Access Compliance Report Public Rights-of-Way (Curb Ramps)

Intersection ID: 27658Main Street: GUNPOWDER_POINT_DRCross Street: W_S_LEE_CTLocation:NEADA ID: 4A8211F690CFRamp Type: PerpInitial Pass/Fail: FailOverall Compliance: NoSeverity Score: 12.5

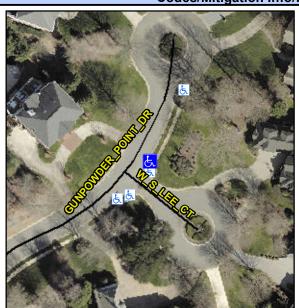
Not Found, R304.2.2

Field Measurements/Component Compliance							
	Compliance Description		Data	Compliance Description		Data	
	N/A	Ramp Length (in)	49.0	No	Ramp Slope (%)	8.7	
	Yes	Ramp Width (in)	53.0	Yes	Ramp XSlope (%)	1.2	
	N/A	Flare Type LT	N/A	N/A	Flare Type RT	N/A	
	N/A	Flare Slope LT (%)	N/A	N/A	Flare Slope RT (%)	N/A	
	N/A	Flare Traversable LT?	N/A	N/A	Flare Traversable RT?	N/A	
	N/A	Landing Length (in)	N/A	N/A	DWS Provided?	N/A	
	N/A	Landing Width (in)	N/A	N/A	DWS Contrast?	N/A	
	N/A	Landing Slope (%)	N/A	N/A	DWS Length (in)	N/A	
	N/A	Landing X Slope (%)	N/A	N/A	DWS Full Width?	N/A	
	N/A	Landing Curb? (Y/N)	N/A	N/A	DWS Offset (in)	N/A	
	N/A	Shared Landing?	N/A				
	N/A	Gutter Ponding?	N/A	N/A	Gutter Slope (%)	N/A	
	N/A	Gutter Lip Ht (in)	N/A	N/A	Gutter X Slope (%)	N/A	
	N/A	Painted X Walk1?	No	N/A	Painted X Walk2?	N/A	
		X Walk 1 Direction	To NW		X Walk 2 Direction	N/A	
	N/A	X Walk 1 Width (in)	N/A	N/A	X Walk 2 Width (in)	N/A

Remove & Replace Entire Ramp.
